November 24, 2021

Subject: Laurel Elementary School HVAC Replacement
San Mateo - Foster City School District
Aedis Project No. 2021005.03
DSA Application #01-119551

ADDENDUM NO. 1

**AD1-
MP0.02**

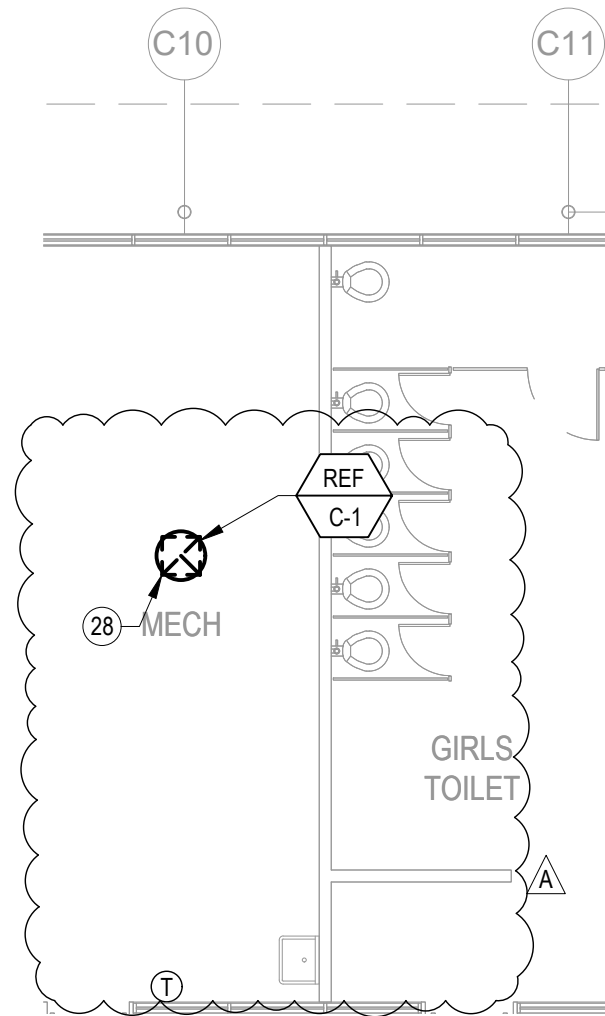
Revise: Classroom split system heat pump schedule per AD1-MP0.02.
Add: Roof exhaust fan schedule added per AD1-MP0.02.

LAUREL ELEMENTARY SCHOOL - HVAC REPLACEMENT	
		SAN MATEO-FOSTER CITY SCHOOL DISTRICT	
387 S. 1st Street, Suite 300 San Jose, CA., 95113	tel: (408) 300 - 5160 fax: (408) 300 - 5121	FILE NO.: 41-26	SHEET
		APPL NO.: 01-119551	REF. SHEET MP2.03
		JOB NO. 2021005.03	AD1-MP2.03a
		DATE 11/24/2021

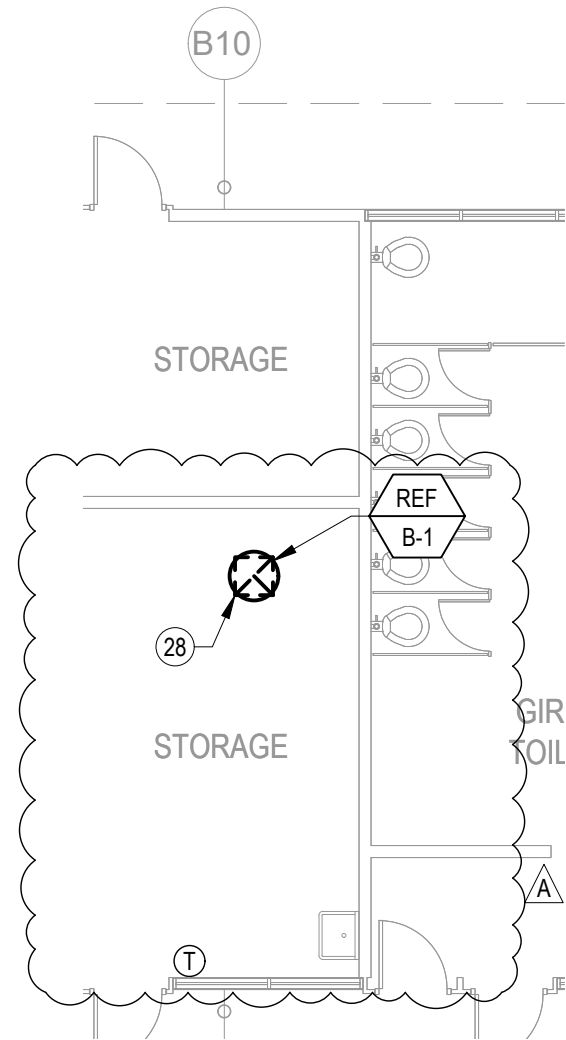
Revise: General notes #4 & #5 per AD1-MP2.03a.
Add: New Sheet Notes #28 per AD1-MP2.03a.
Add: Roof exhaust fan added to plan per AD1-MP2.03a.
Add: Roof exhaust fan added to plan per AD1-MP2.03b.

SHEET
**FLOOR PLAN -
NEW - BLDG A -
MECHANICAL &
PLUMBING**

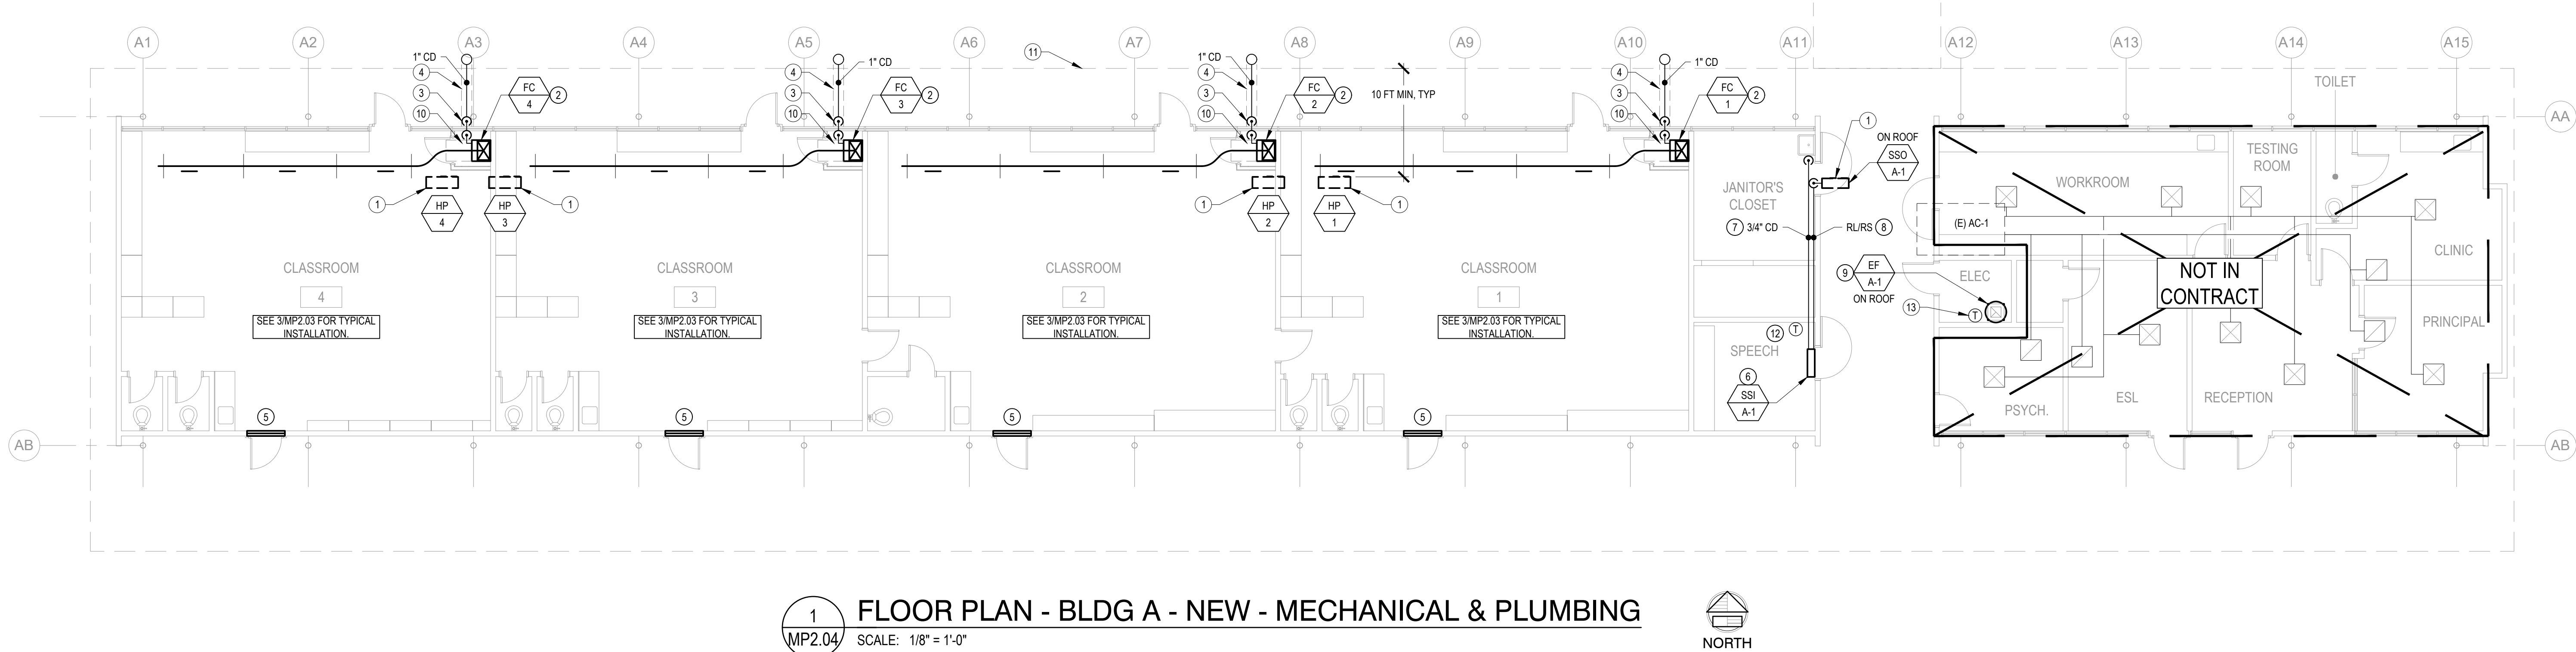
Revise: General notes #4 & #5 per AD1-MP2.04

Add: Multi-Purpose Floor Plan per AD1-MP2.04
Add: New Sheet Notes #14 per AD1-MP2.04

SHEET
REF. SHEET MP6.01
AD1-MP6.01a

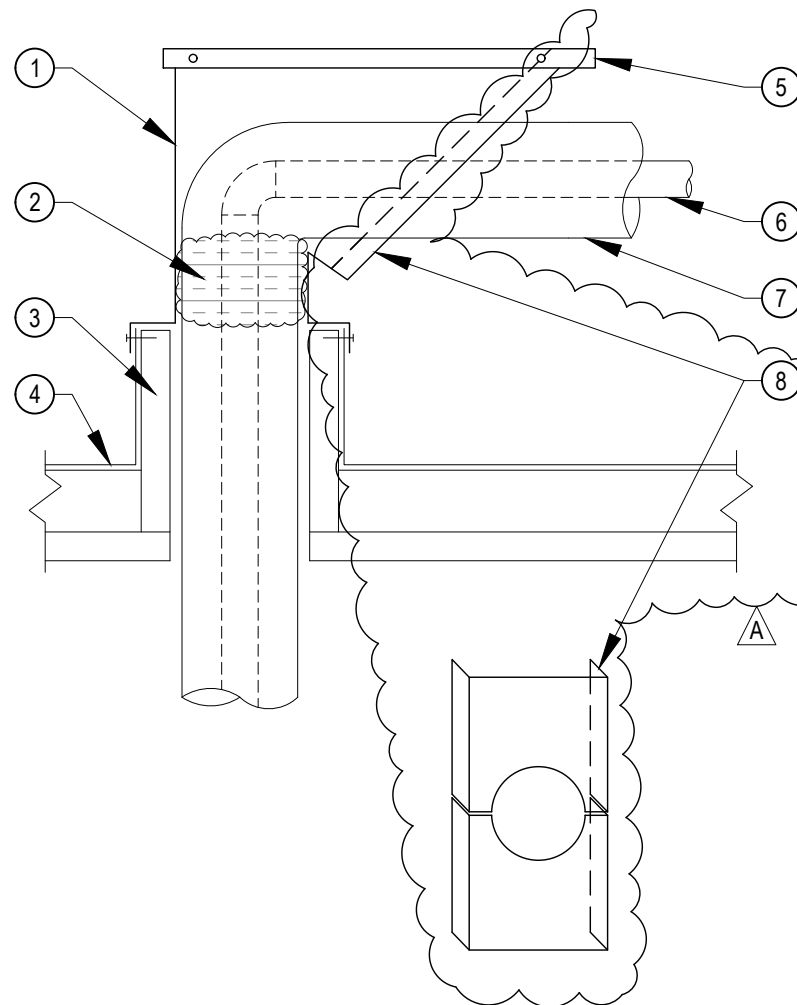
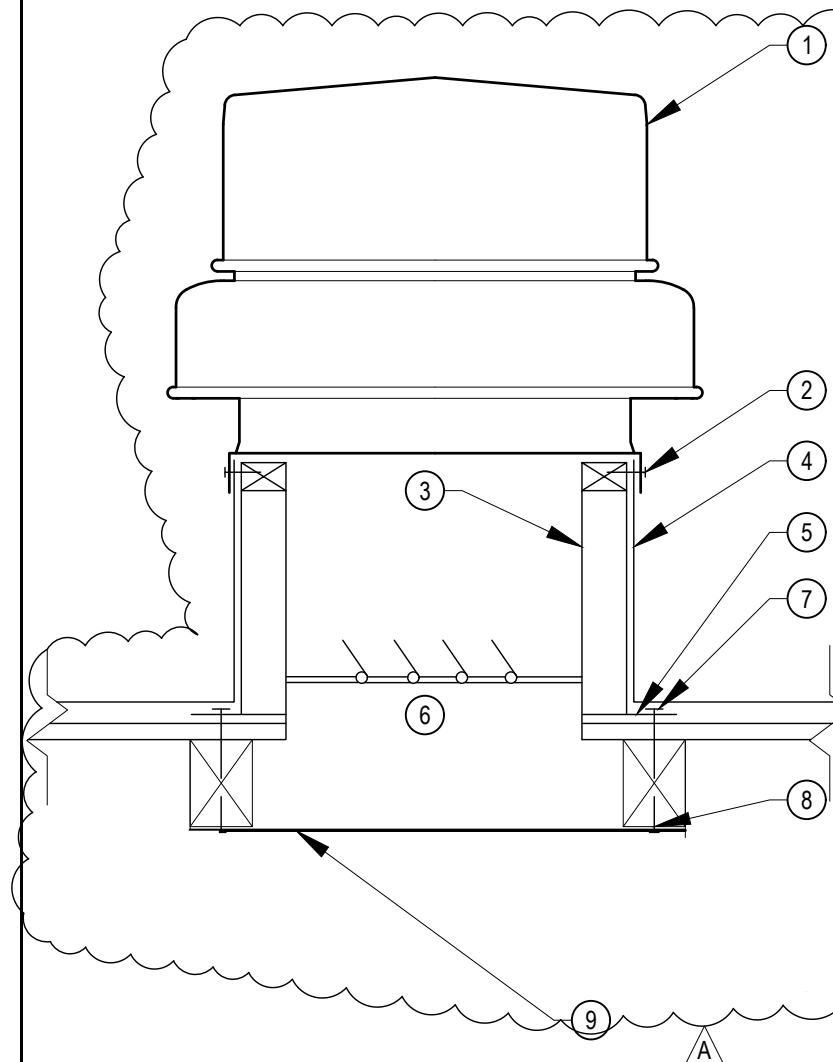
Revise: Detail 4 per AD1-MP6.01a
Add: Detail 6 per AD1-MP6.01a
Revise: Detail 14 as shown clouded on AD1-MP6.01b

SHEET # AD-1
E1.1

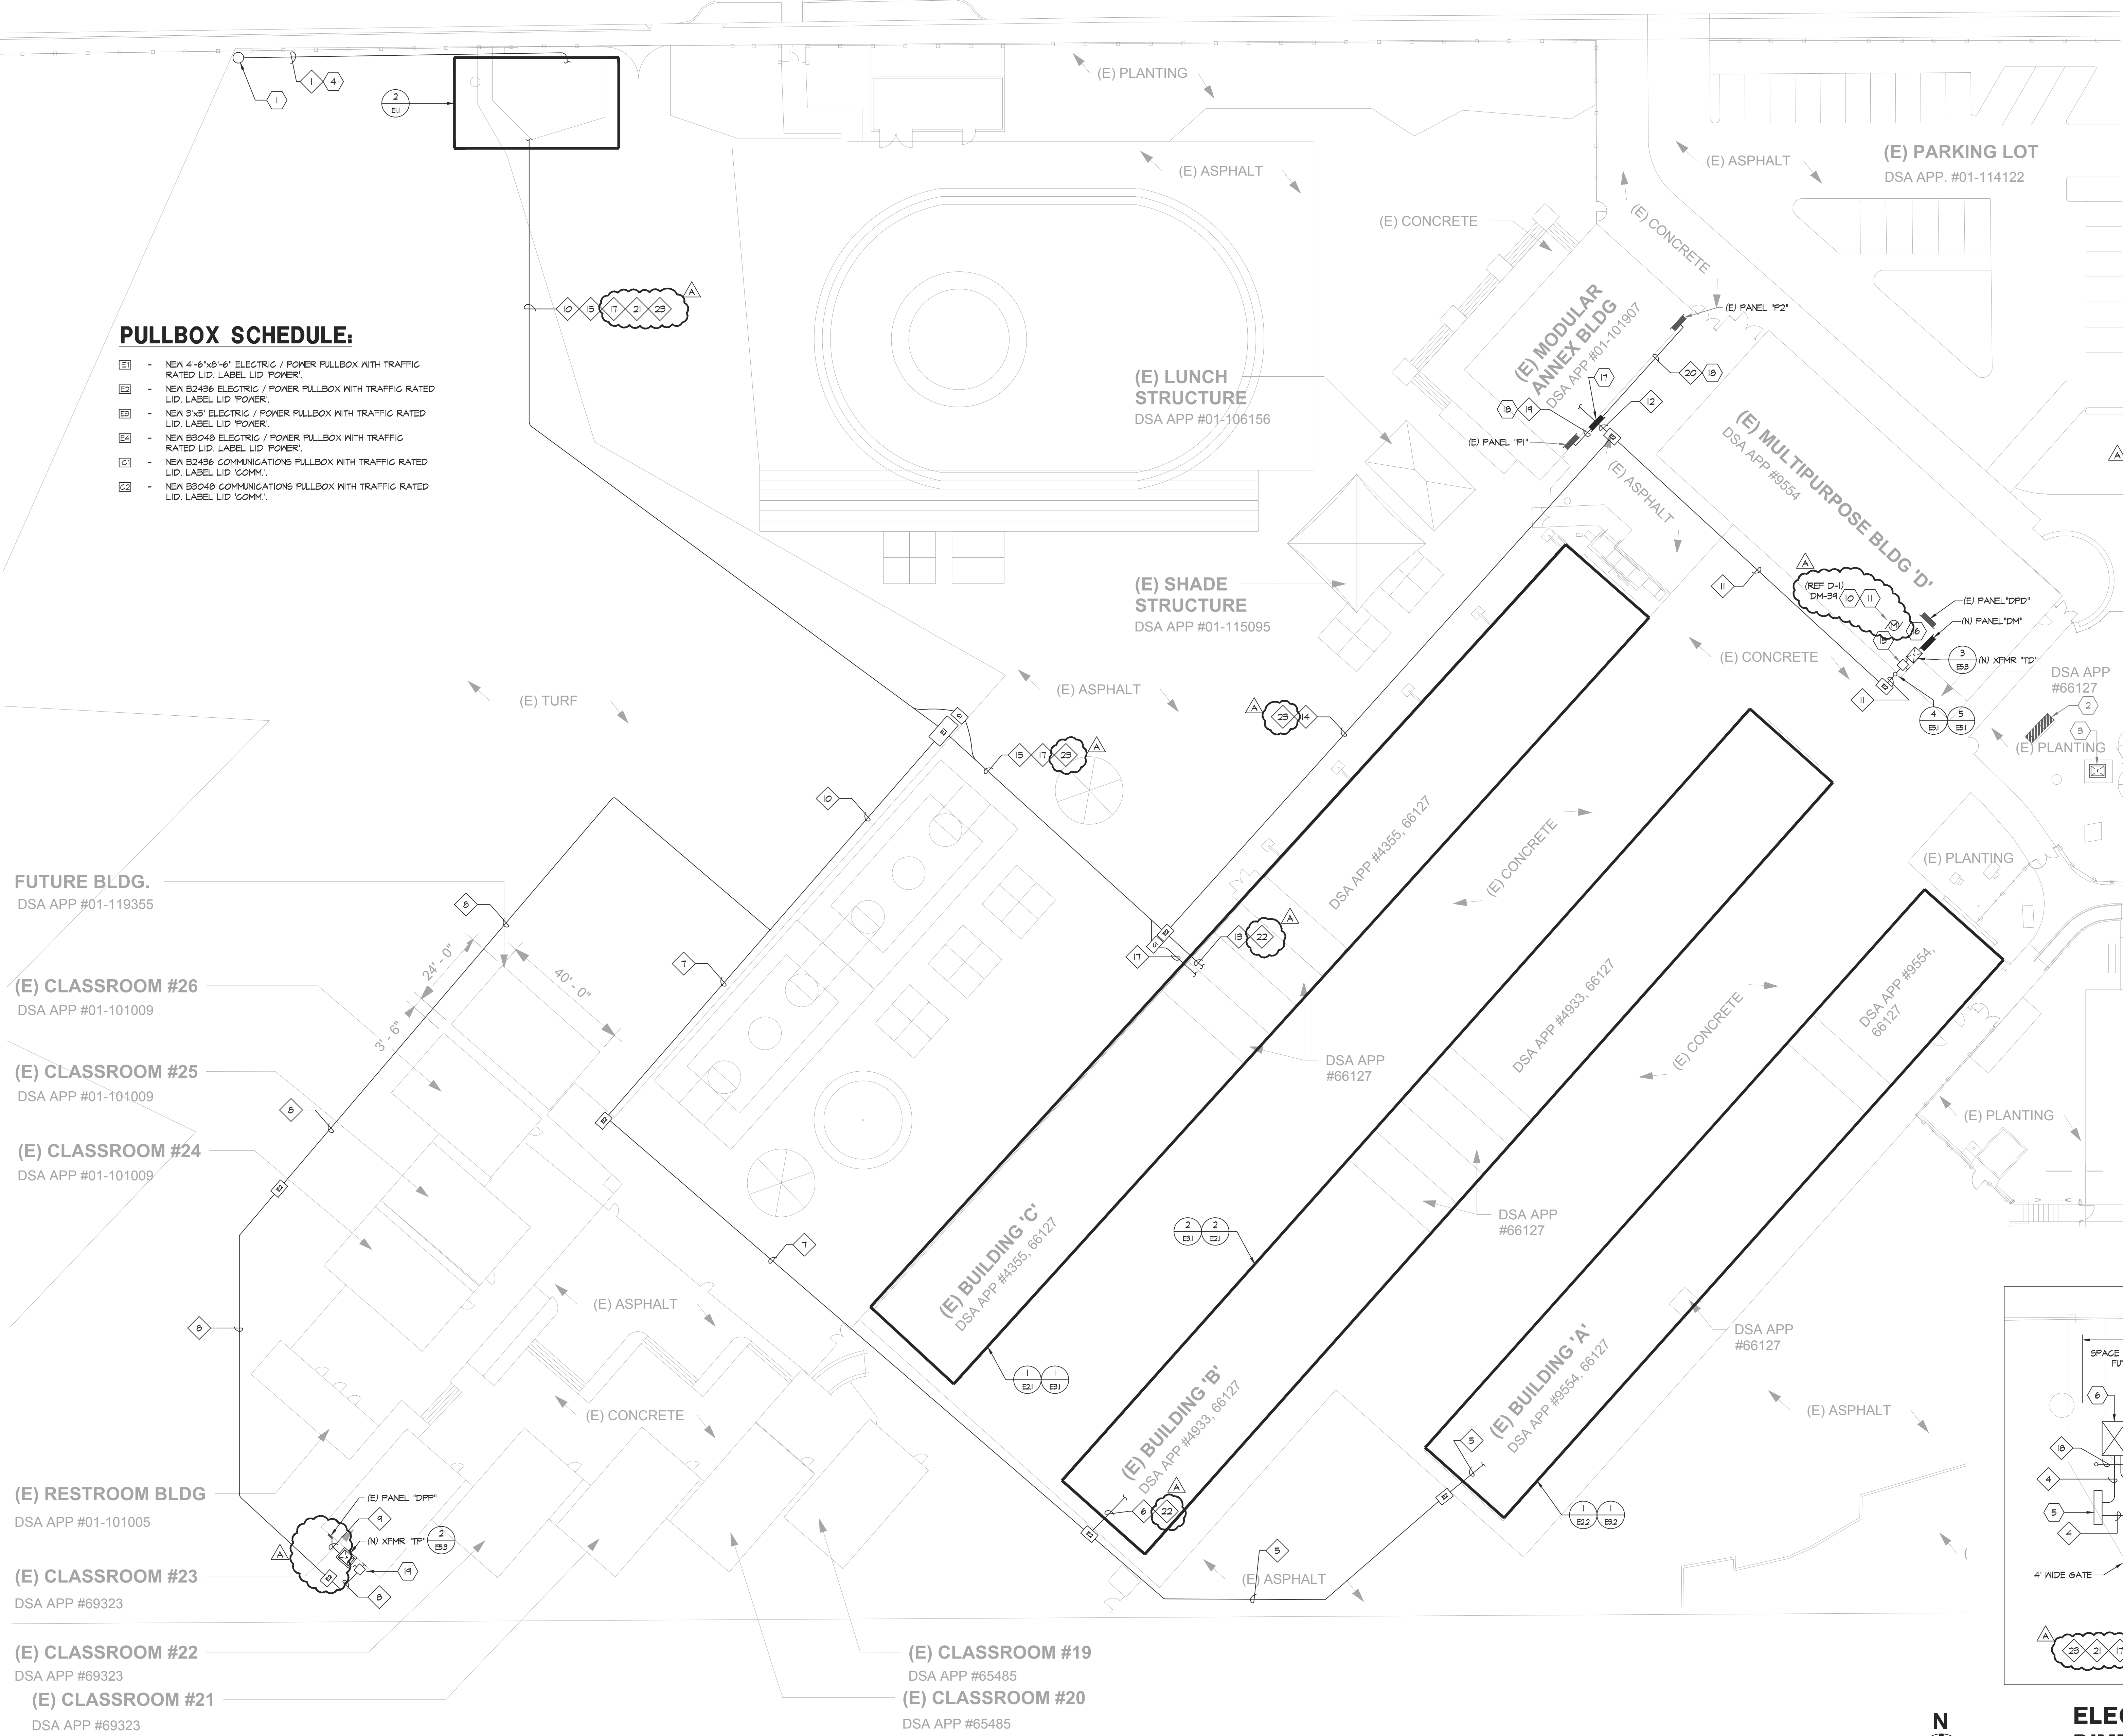
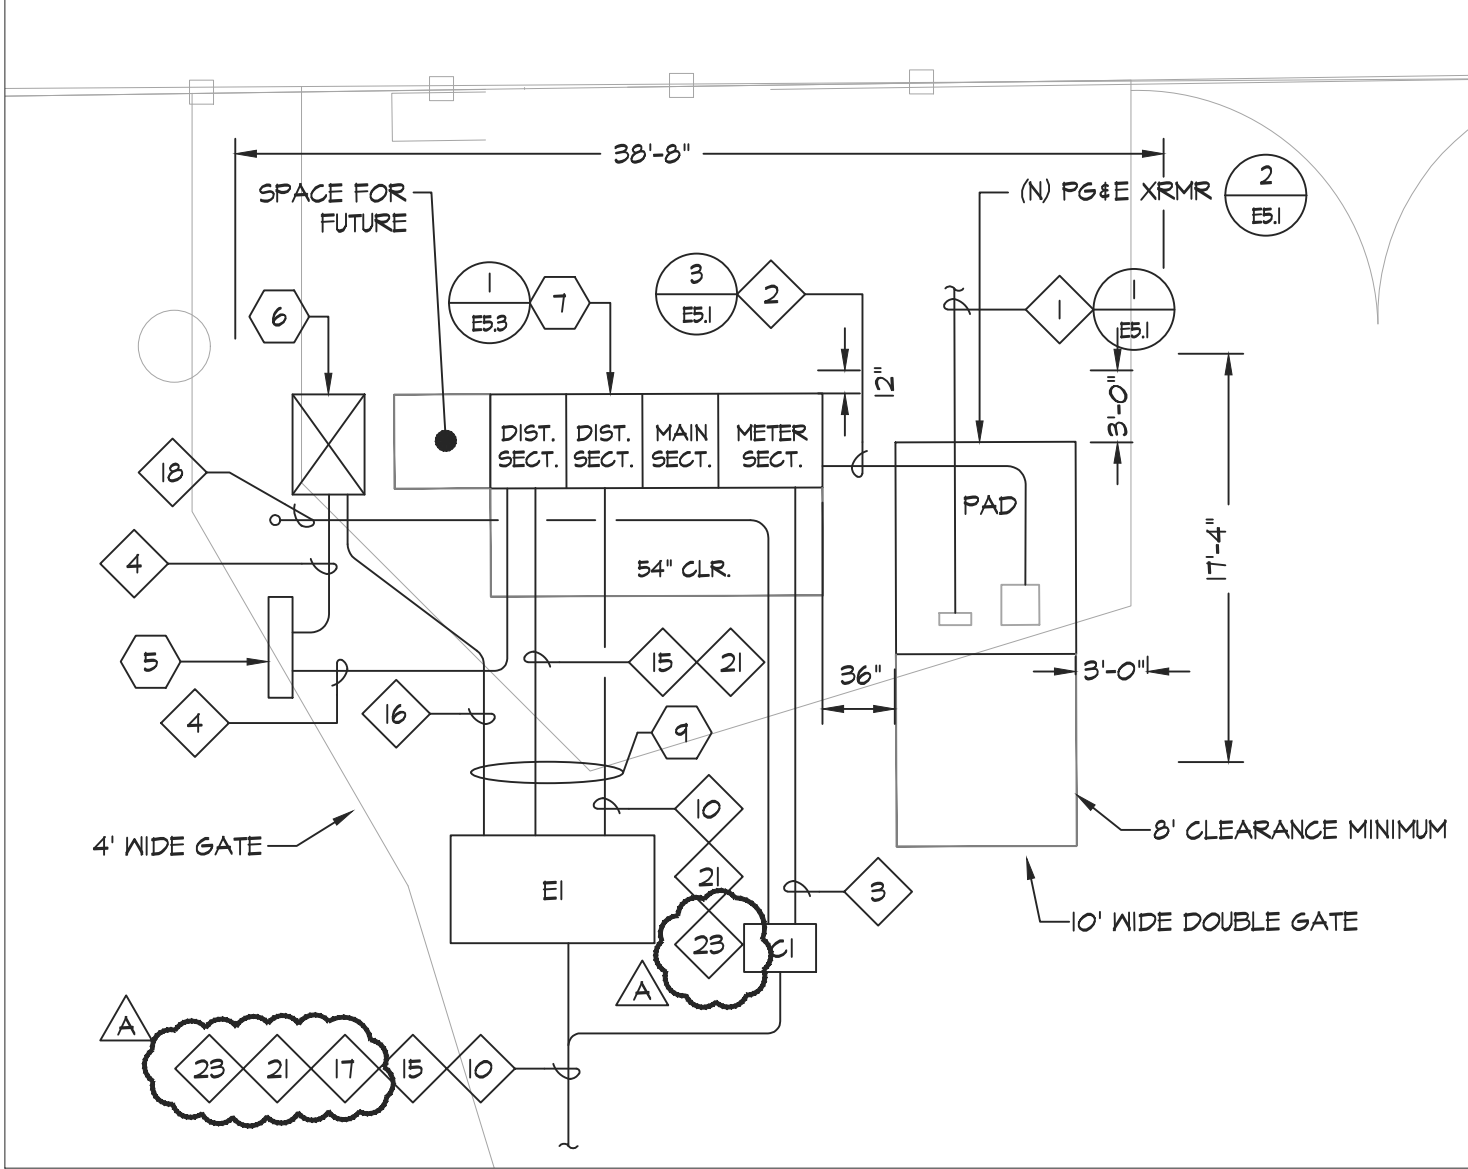
Revise: Conduit Tag #9 per AD1-E1.1
Revise: Sheet Notes #10 & 11 per AD1-E1.1
Add: Conduit Tag #22 and #23 per AD1-E1.1
Add: Power for exhaust fan at building D per AD1-E1.1
Revise: Conduit tag callouts per AD1-E1.1
